A SUPPLEMENT TO THE PENTAX 6X7 SERVICE MANUAL

NOTICE OF MODIFICATION

Model PENTAX 6x7

NOTICE OF MODIFICATION

5 Counter Transport Button

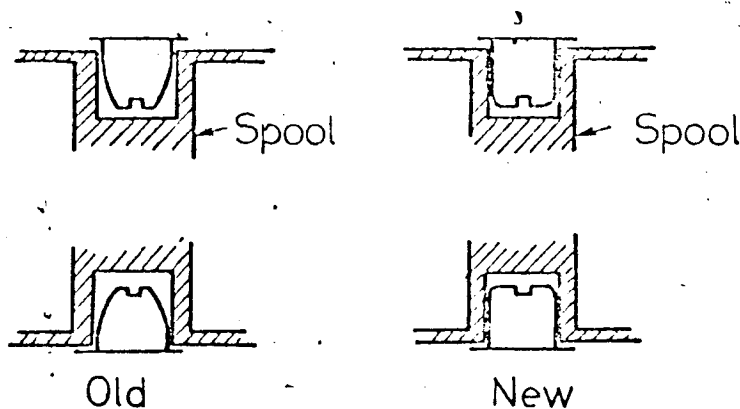
To advance Exposure Counter directly, eliminating operation to the counter roller. The shutter comes into "operational" by closing the back cover or placing a coin plate into position, after the dial has turned beyond No. 1 marking by mean of the button.

Never turn the button if the dial stops off the starting position or if the back cover is closed, regardless of whether the camera is loaded or unloaded.

Old and new Exposure Counter Dial are the same except for a provision of 8 engaging hollows in the new.

(1) Damper Gear Adjustment

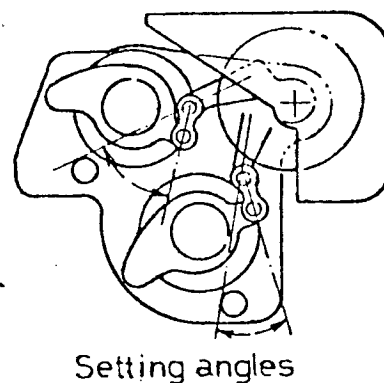
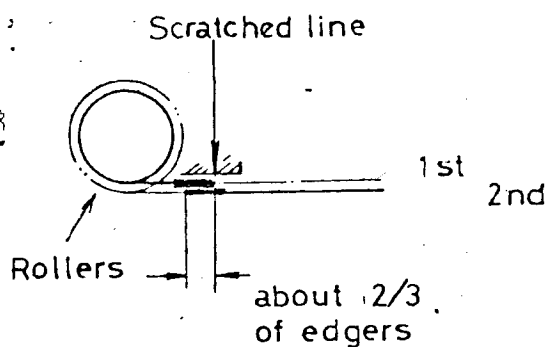
When engaging the damper gears, the setting angles of the damper arms should be greater than that of the old type.

When the damper disk hits the stopper, the curtain positions should be:

1st Curtain

Near the scratched line. Over traveling may be allowable so long as the edger does not contact the rollers.

2nd Curtain

About 2/3 overlapping of the edgers.

(2) Bounce Prevention Adjustment

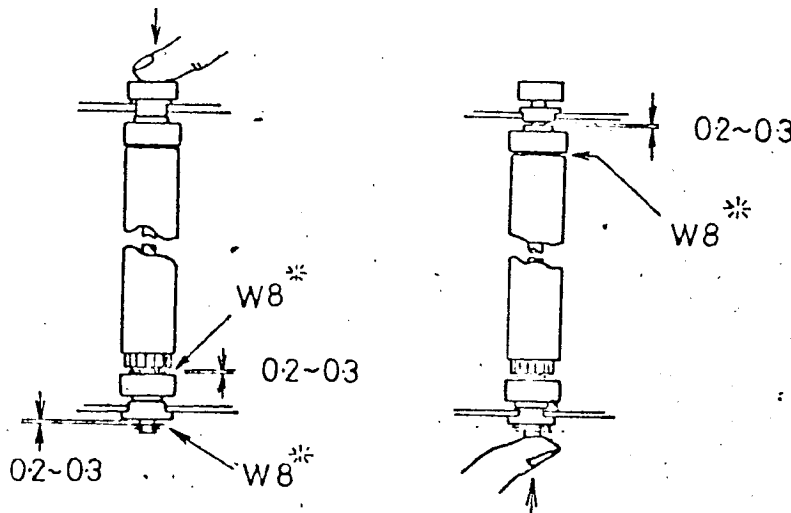
On the recent type with friction springs, Damper Disk (0-E21-1) do not stop contacting the stopper after the curtain traveling: a clearance of about 3 mm will remain even at optimum adjusting point, because of the backward movement of the spring.

This adjustment can be settled by screwing in of the adjusting nut half-way, since the adjustment domain is now considerably larger than that of the old type.

(2) Overlapping Of The Curtains

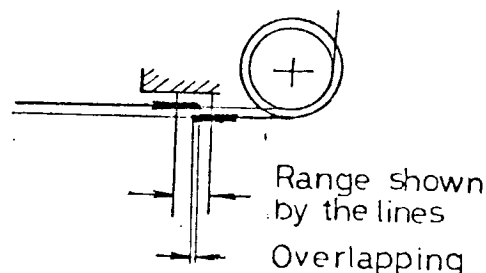
These are rated under the condition in which both 1st and 2nd selector gears are checked.

2nd Curtain The edger, between the two scratched lines.

1st Curtain Overlapping :
 $0 \pm 0.1 \text{ mm}$

Parts
Description

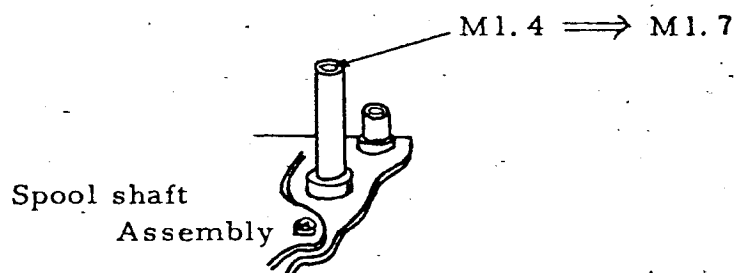
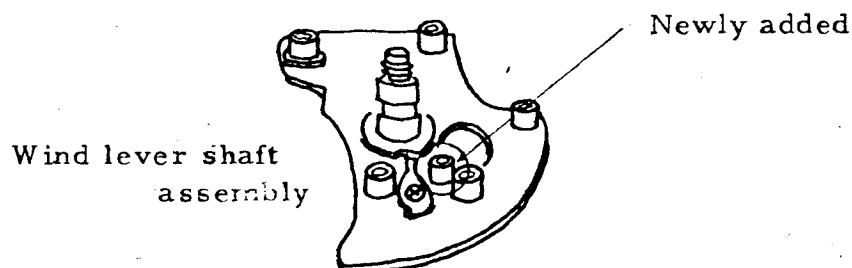
Screw (CSS1.7 x 2.5) instead of CSS1.4 x 3.5 is used at the shaft on Spool shaft assembly.

To prevent both the teeth of C42, C43 and the screw head (CSS1.4 x 3.5) from being broken.

Also prevent uneven clearance between the frames from appearing.

No interchangeability between old and new, but interchangeable when used in a combination.

Parts No. A3
B58 A102 A105 A58Description Side cover left assy.
Synchro terminal assy.

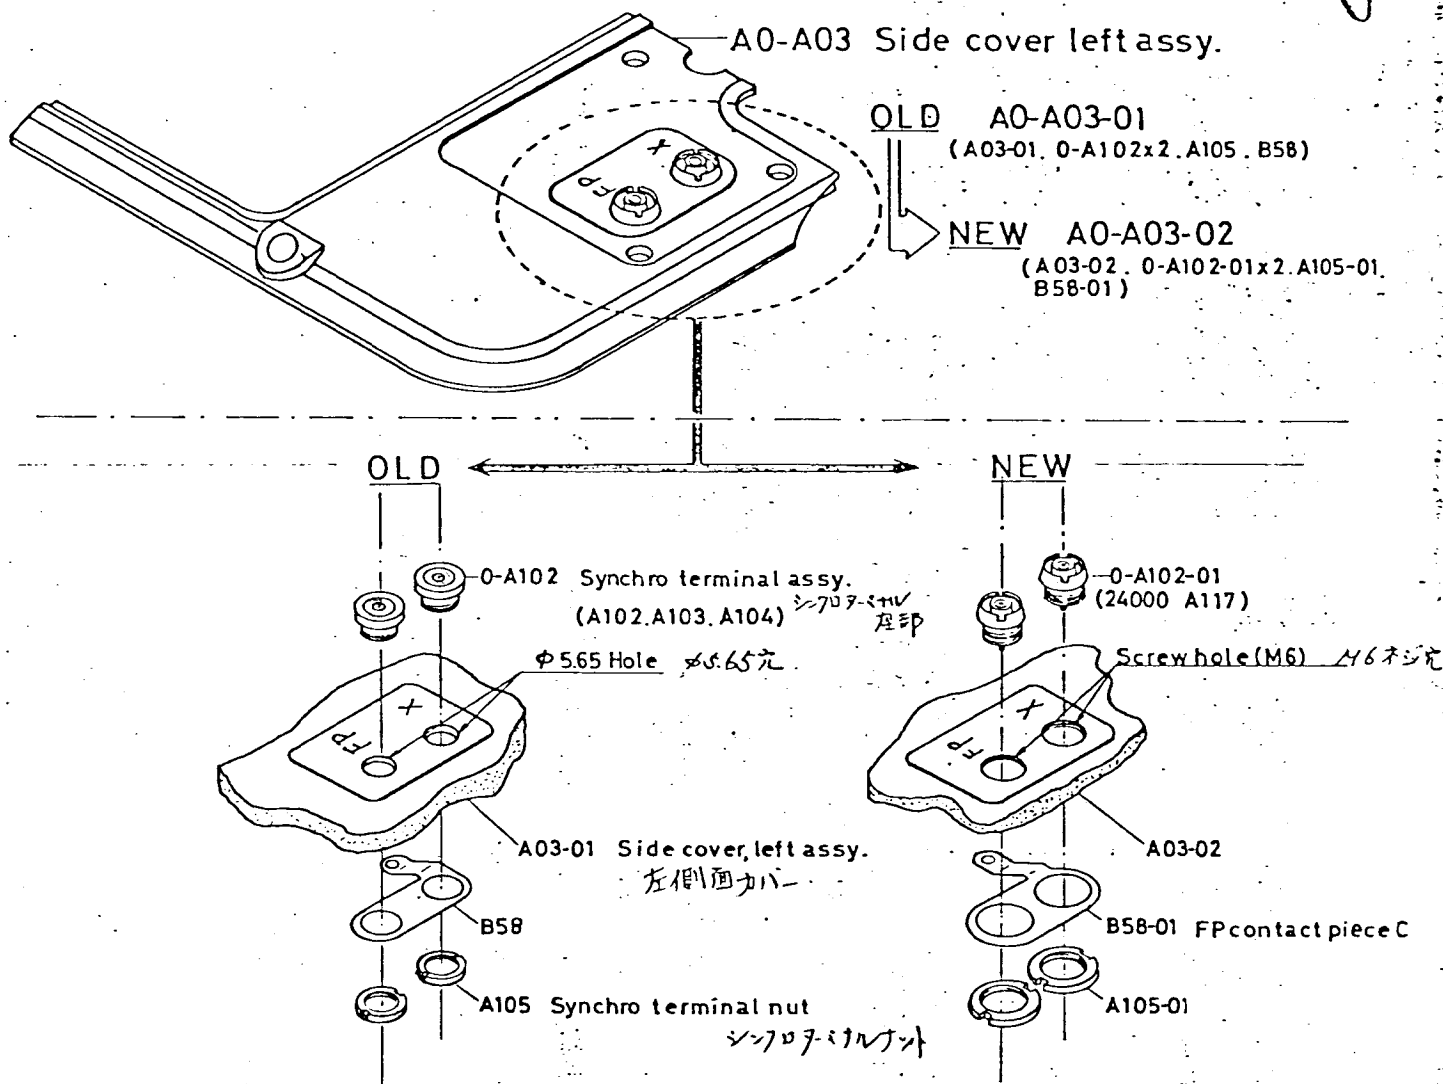
The parts have been modified as shown below. 下記部品が変更の通りになる。

To make using of 4P Synchrocord A (AF400T).

New parts (0-A102-01, A105-01, B58-01) can be used to A03-01 if the φ 5.65 hole was made M6 screw hole.

Description Clutch disk spring

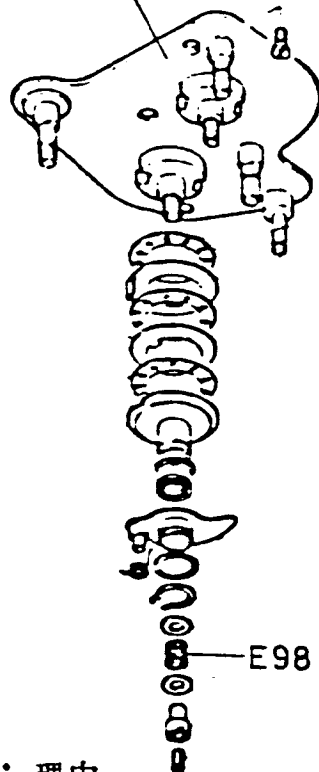
The parts below have been changed as follows.

E98 → E94

Wire diam. 0.50φ → 0.55φ

Both adjustment can be made by E94 Clutch disk spring.

Interchangeable between old and new parts.

Fig.2 第2図

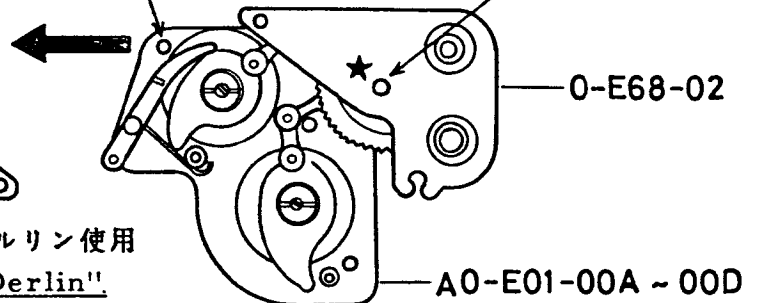
E97 to be replaced with
CNS1.7x3

To increase the durability and the accuracy of shutter speeds.

Interchangeable between old and new parts. But when installing Damper mech. assembly A0-E01-00A~00D to Mirror box assy. that comes with the new Shaft plate B assy. 0-E68-02, following procedures are required to stabilize shutter speeds under a low temperature condition.

Reason: By installing A0-E01 to Mirror housing assy. with 0-E68-02, the mesh of the A0-E01's gear and Pinion shaft gear will be fastened.

2. In this condition, if the screw (CNS2x2.2) does not fit into ★ the hole due to Damper mech. assembly has been shifted as mentioned earlier. Consequently, file or ream with a reamer (make a hole $\phi 2.2$ to approx. $\phi 2.5$) then fasten the screw (CNS2x2.2).

Remark: Above mentioned the procedure is required untill a modified part of A0-E01 supplies.

1. Replace Shaft retainer screw E97 with a standard screw (CNS1.7x3).

While shifting Damper mech. assembly to the arrow direction  as shown in Fig.2 above, then fasten the screw (CNS1.7x3).

Description Shock damper retainer screw.

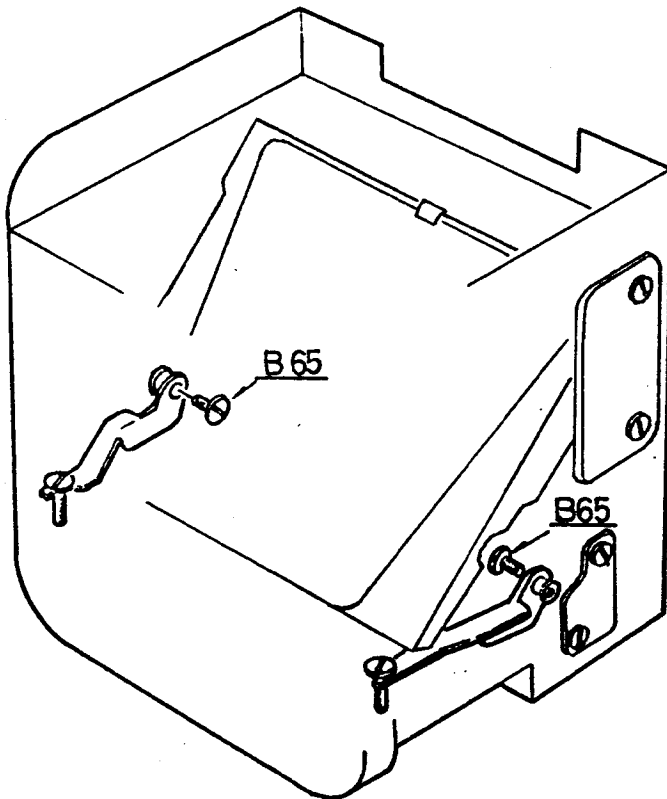
B65 Shock damper retainer screw has been removed and CNL-E 1.7x2.2 (PB-9) Screw has been used instead of B65.

Removed ⇨ B 65

CNL-E 1.7x2.2
(PB-9)

Interchangeable between old and new parts.

Description Wiring board assembly
(Distributing wires)

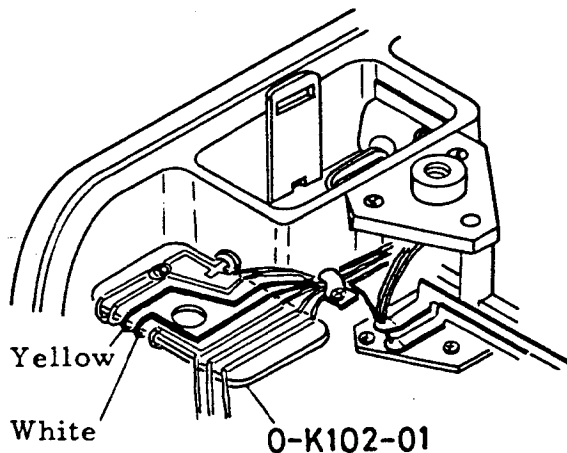
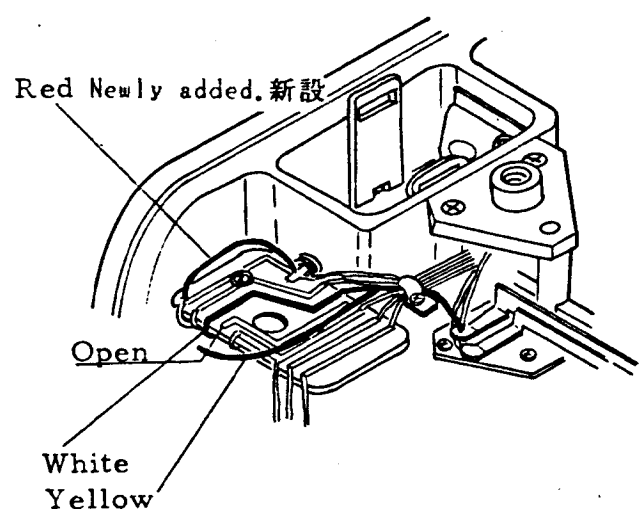
The wiring positions of the white and the yellow lead wires have been changed as shown below.

While taking Time exposures, to prevent the shutter from being released caused by leakage of 0-K02-01 Wiring board assembly.

For safety measure, the red lead wire as shown in Fig.2 (length Apporox. 30mm) has been added to supply electric power souce more surely.

Fig. 3

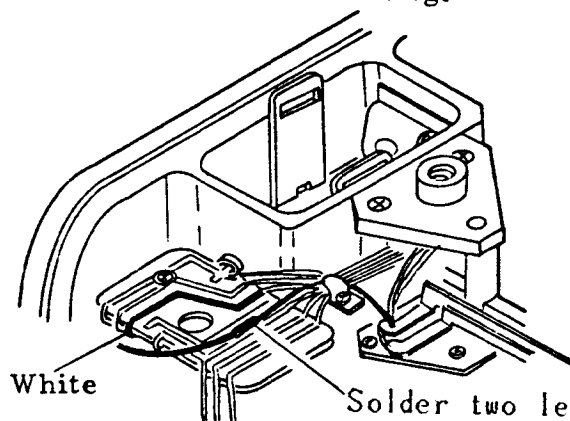
If following malfunction happened, to repair, solder the two yellow lead wires then wrap it with electric tape and bundle with other lead wires as shown in Fig.3.

2本のリード線を半田付けし、絶縁テープを巻く。
Solder two lead wires then wrap it with electric tape.

Description Wind lever shaft screw

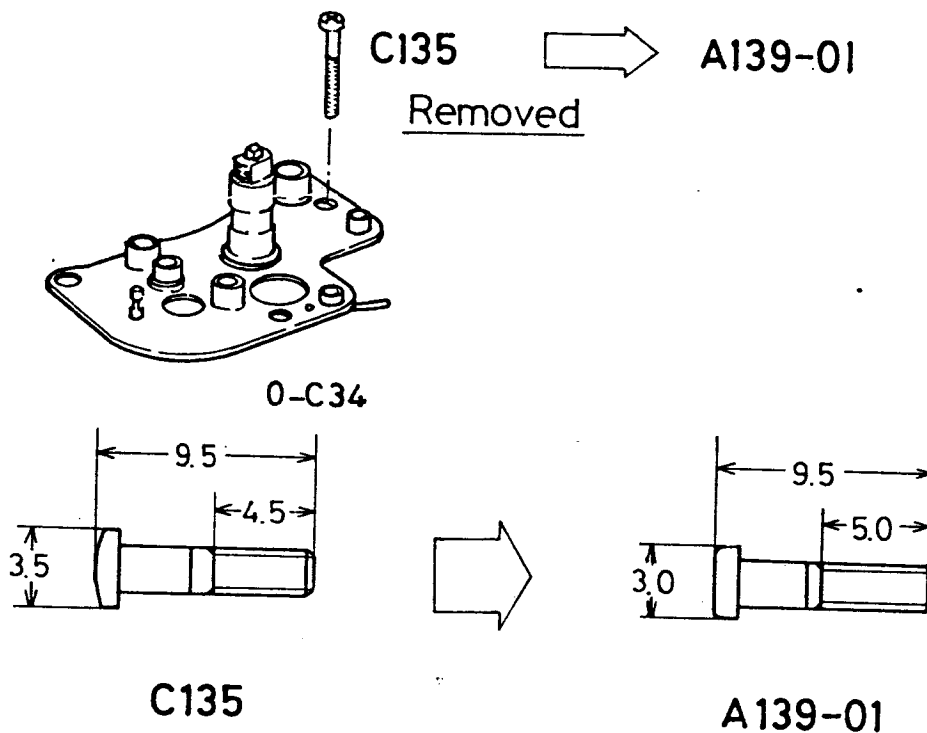
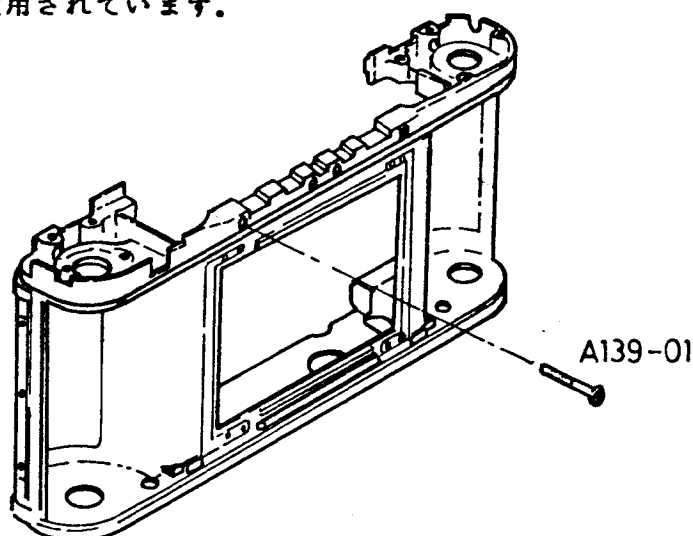
Wind lever shaft screw (23401-C135) has been removed as shown below.

23401-A139-01 is used instead of 23401-C135.

23401-A139-01 is used as shown below.

Description Shutter actuator lever spring

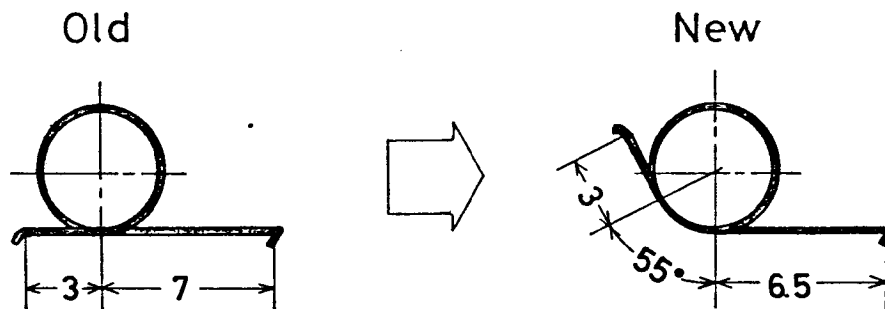
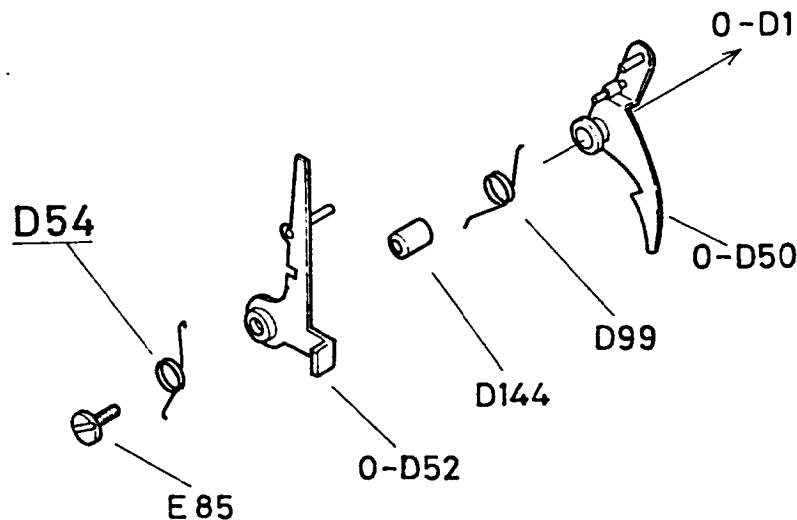
The part has been modified as shown below.

When released shutter at "B" position, to prevent Second Shutter Curtain from not releasing.

Interchangeable between old and new parts.

Description Mirror seat assembly.

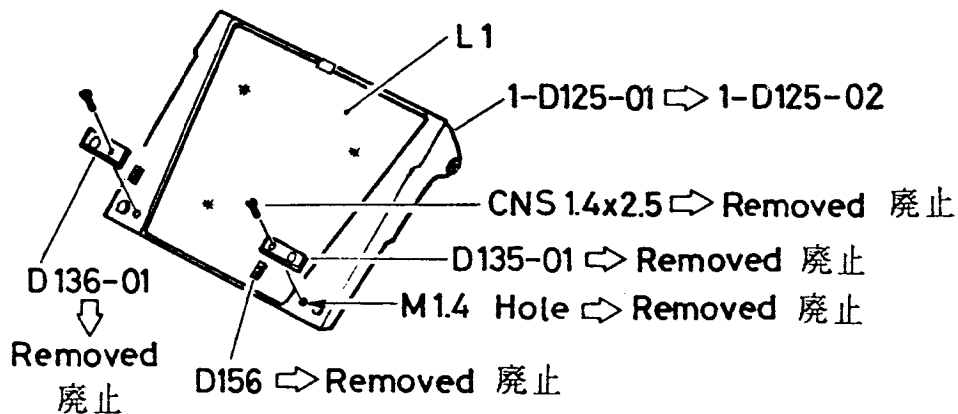
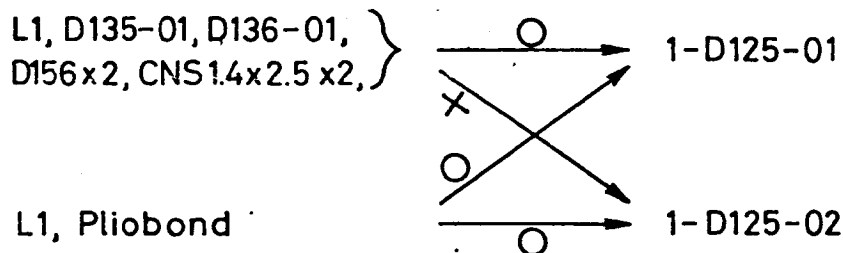
The parts have been removed and modified as shown below.

To prevent L1(Mirror) from warping.

How to affix L1.

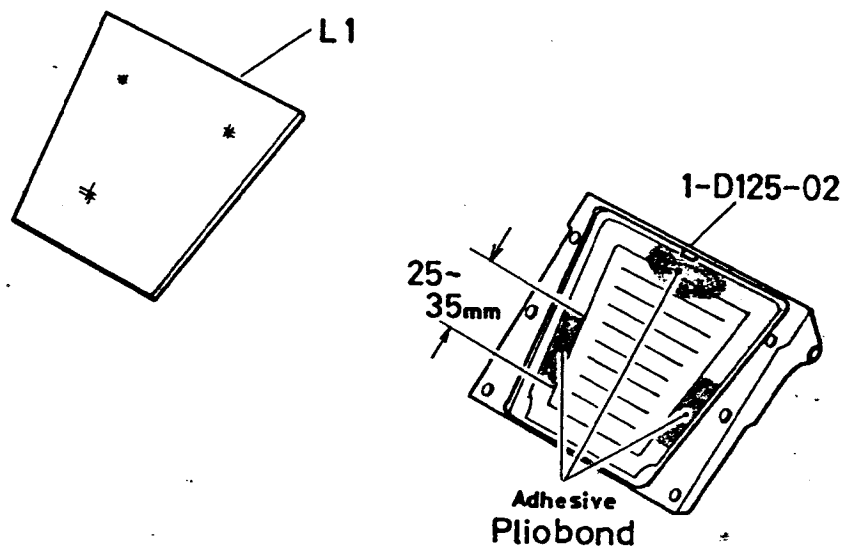
Apply pliabond to 1-D125-02(Mirror seat assy.) as shown below,
then affix L1 and leave it approx. 24 hours.
